**Town of Kittery Maine
Town Planning Board Meeting
November 9, 2017**

10 Spinney Cove Drive – Shoreland Development Plan Review.

Action: Hold a public hearing, approve or deny development plan. Owner and applicant, Lobo Realty, LLC request consideration to demolish and replace a nonconforming single family dwelling on a 0.44 +/- acre parcel located on Spinney Cove Drive (Tax Map 2 Lot 64) in the Residential Suburban (R-S) and Shoreland Overlay (OZ-SL-250') zones. Agent Bob Bordeau, Lobo Realty, LLC.

SHORELAND DEVELOPMENT PLAN
 FOR PROPERTY AT
10 Spinney Cove Drive
 Kittery, York County, Maine
 OWNED BY
Lobo Realty, LLC
 187 White Mountain Highway, Milton, NH 03851
 PREPARED FOR APPLICANT
 Bob Bourdeau
 187 White Mountain Highway, Milton, NH 03851

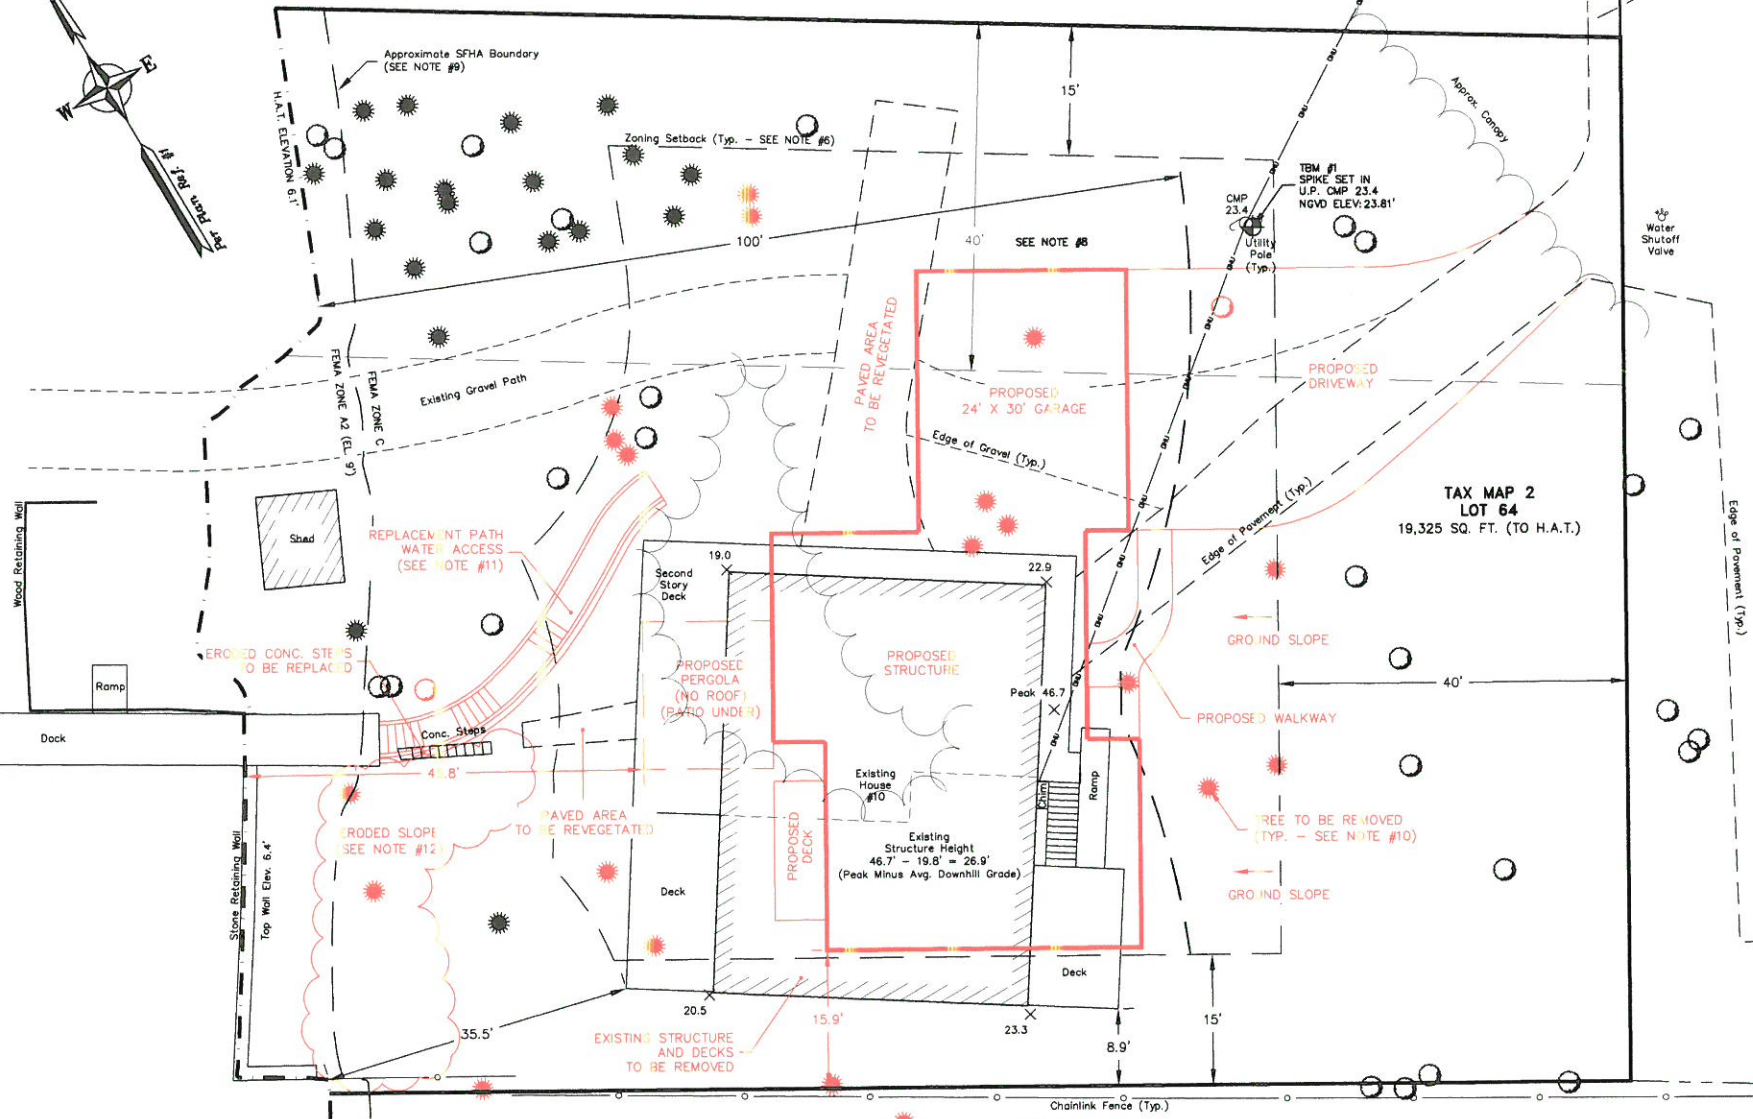
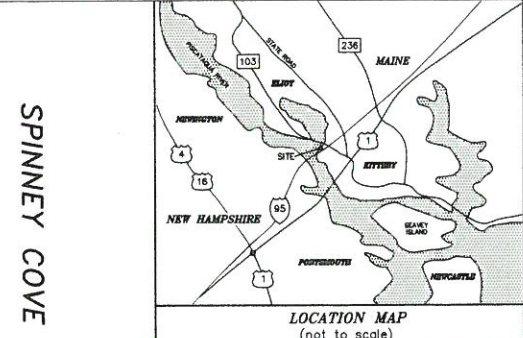
UPDATE: The latest shoreland development plan appears to have been revised, however revision block does not identify any changes, though the date in lower right-hand corner has changed to 10/25/17. The devegeatated calculations have changed to include what appears to be a reduction in the *path* and the addition of the *walkway*. The applicant should calrify and explain these changes, however the results remain within the existing devegetated area of 28.7%.

UPDATE: The revised plans still depict the proposed walkway within the 100-foot required setback. New structures are not allowed. A meandering path may be maintained for access to the water within the 100-foot setback/buffer, however it cannot be improved, i.e. surfaced with gravel, pavers, etc.... At the last meeting the applicant stated that his agent was working with MDEP, presumably for a Natural Resources Protection Act (NRPA) permit. If MDEP were to approve the permit with the walkway, it would not be in lieu of the planning board approval of the Town’s local shoreland zoning regulations. The state mandated language that our local regulations are clear that there are no new structures allowed within the required setback. The proposed walkway needs to be removed from the plan.

UPDATE: No exhibit has been submitted that demonstrates the proposed building will be in conformance with the height requirement and the roof slope per 16.7.3.3.2.E.4.a. The Shoreland Development Plan depicts the existing height of the structure being 26.9 feet. This appears to be appropriately calculated per the applicable definition in 16.2.2 *Height of a Structure*.

6. Existing easement. Plan note 8 refers to unknown rights or easements within a 40-foot wide swath along the northerly side of the property. Applicant should provide clarity as to his right to develop (new garage located here) this portion of the property.

7. Standard Boundary Survey. Based on plan references, plan note 7 and no depiction of metes and bounds on the plan, it does not appear, the Shoreland Development Plan references a standard boundary survey. This needs to be clarified and boundaries of the property need to be confirmed such as they can be relied upon for regulatory setbacks and lot area.

8. The revision block should be completed on the Shoreland Development Plan, along with correcting the depicted 75 FT setback under the *OZ-SL-250' Requirements* where it should be 100. *Principle Structure Area* needs to be revised to include the term *footprint* so it is consistent with the regulatory language in 16.7.3. Revise plan note #6 to read *Town of Kittery* rather than *Wells*.

2. On the Shoreland Development Plan dated 10/26/17 Note #6 still references Town of York, not Kittery.
3. Erosion control measures and requirement for a certified contractor are all adequate.

6. Incorporate any plan revisions, including the removal of the proposed new "replacement path water access", on the final plan as recommended by Staff, Planning Board or Peer Review Engineer, and submit for Staff review prior to presentation on final Mylar.

Lobo Realty, LLC
Water Access and Slope Stabilization Plan
10 Spinney Cove Drive Kittery, Maine

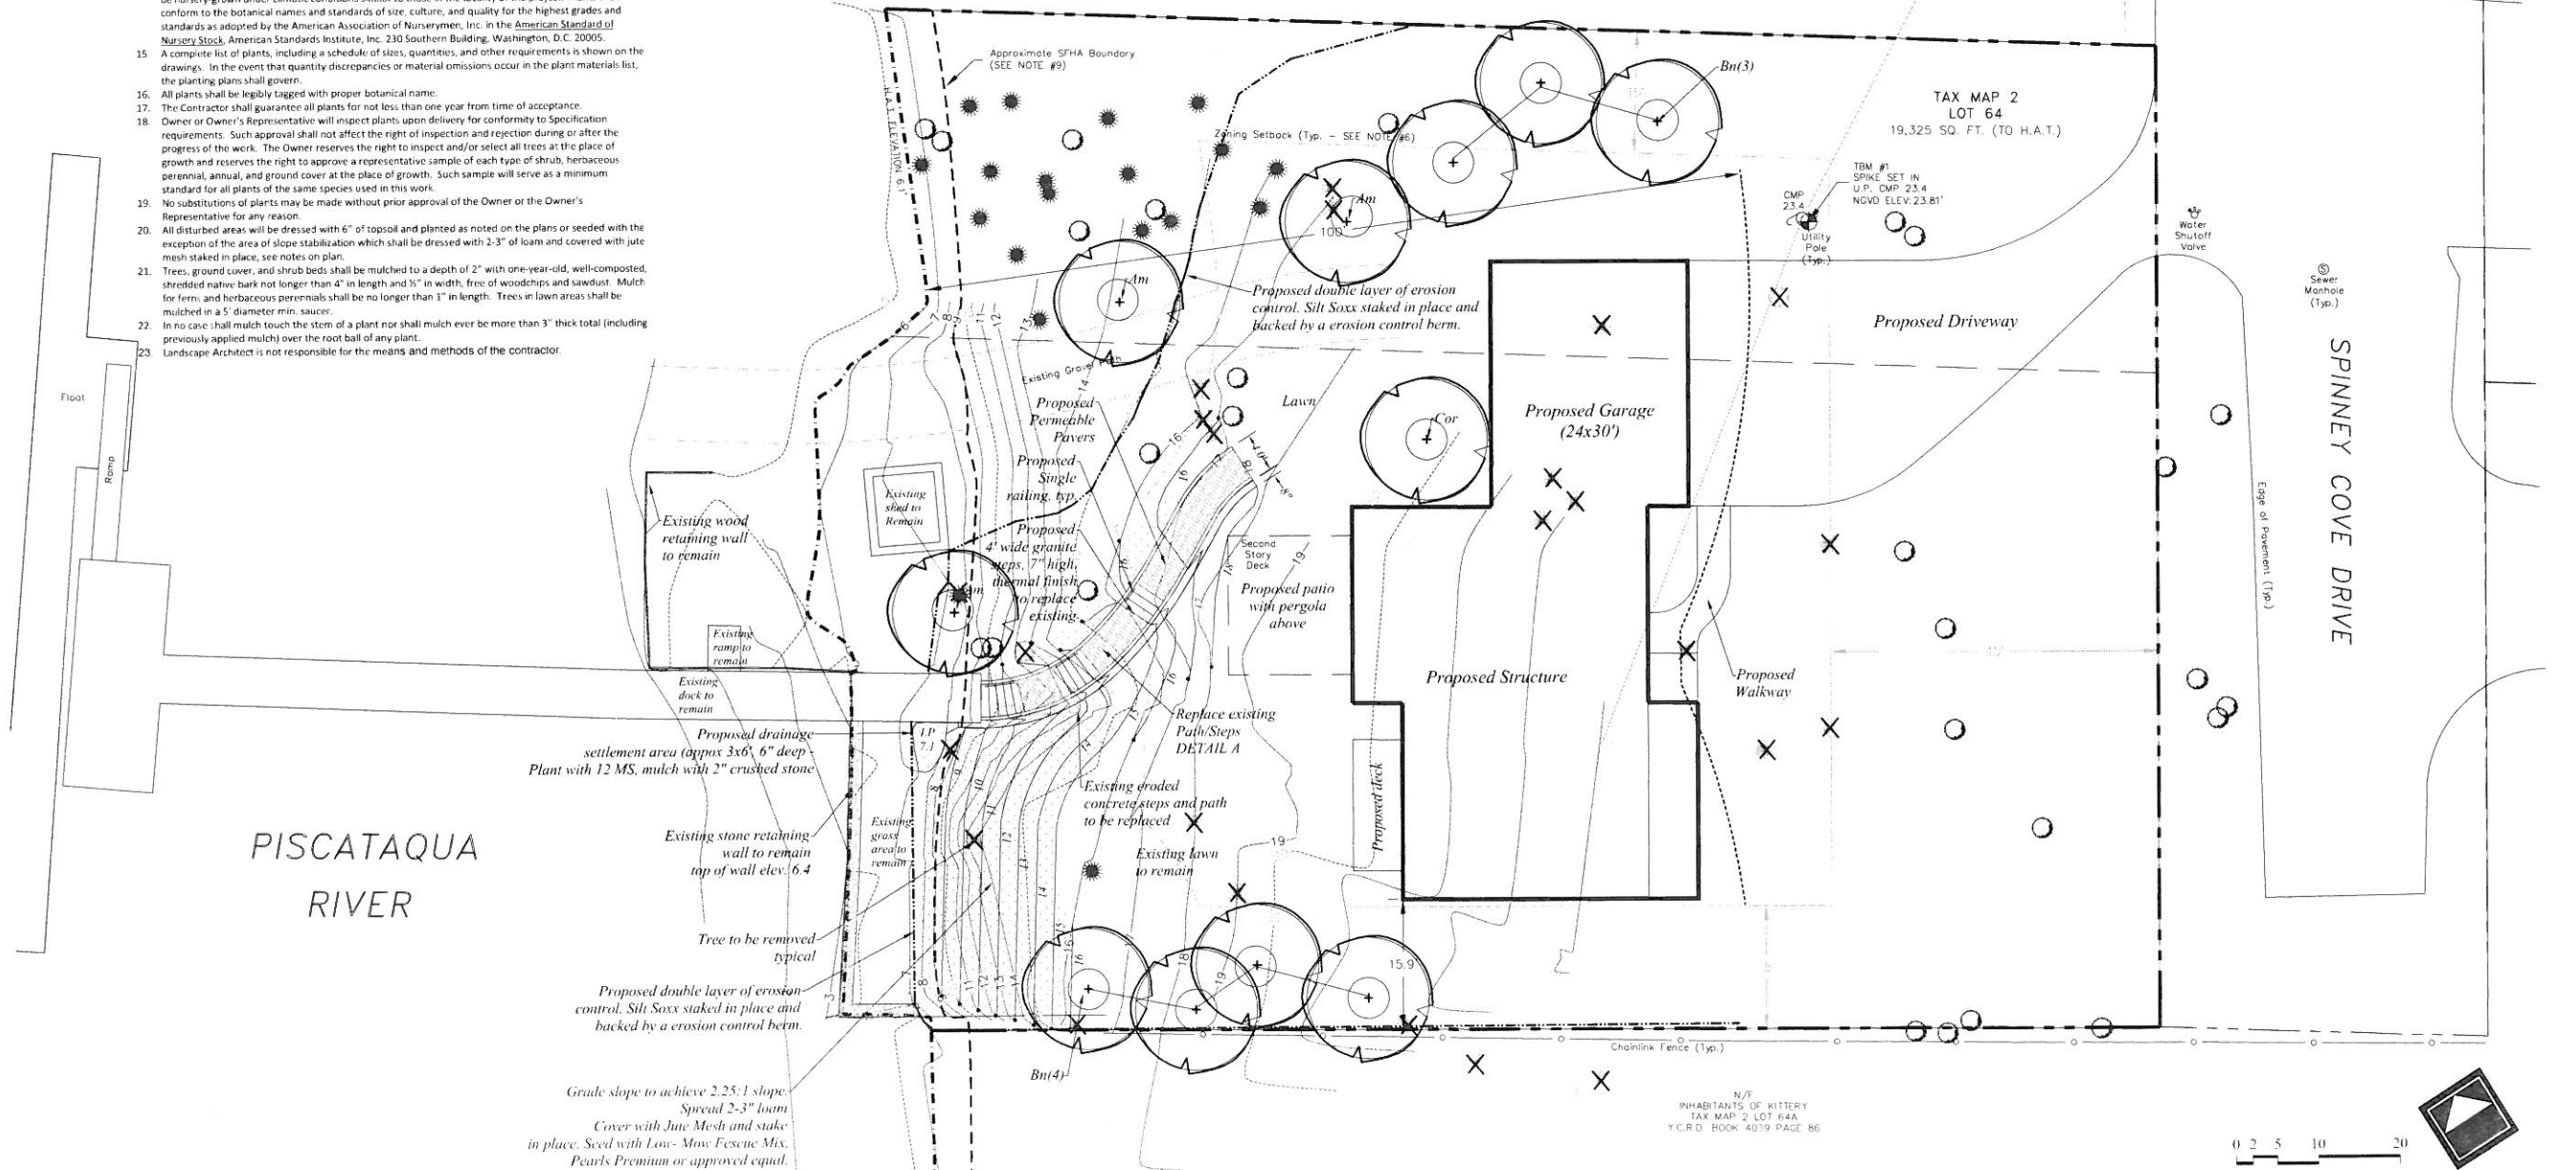
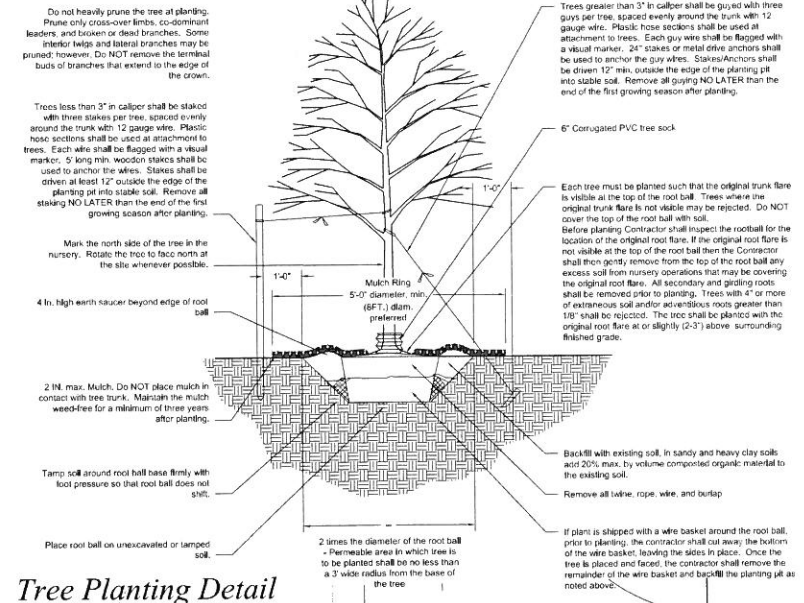
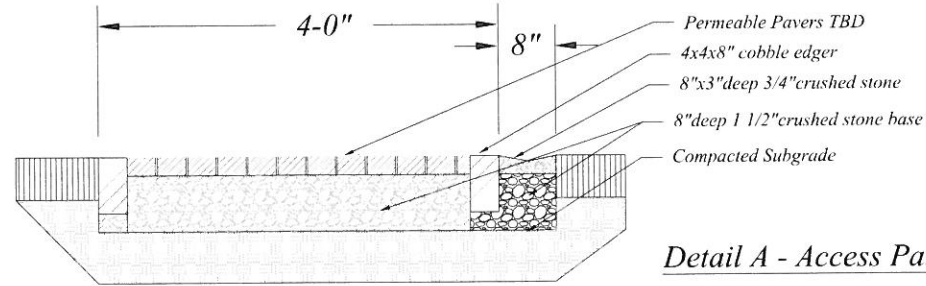
I have reviewed the Water Access and Slope Stabilization Plan dated 2017-10-26 and have the following comments:

1. The plan proposes replanting 11 trees, which meets the minimum number of 10 trees I had previously required based on a site walk on 8/30/17. However, per 16.7.3.3.1.C.2 *"Trees removed to relocate a structure must be replanted with at least one native tree, six (6) feet in height, for every tree removed. If more than five trees are planted, no one species of tree can be used to make up more than 50% of the number of trees planted. Replaced trees must be planted no farther from the water or wetland than the trees removed."* The plan calls for 3 Amelanchier trees sized 2-2.5" caliper and just want to be sure this will meet the minimum 6 foot height requirement. The other conditions for 16.7.3.3.1.C appear to be met.
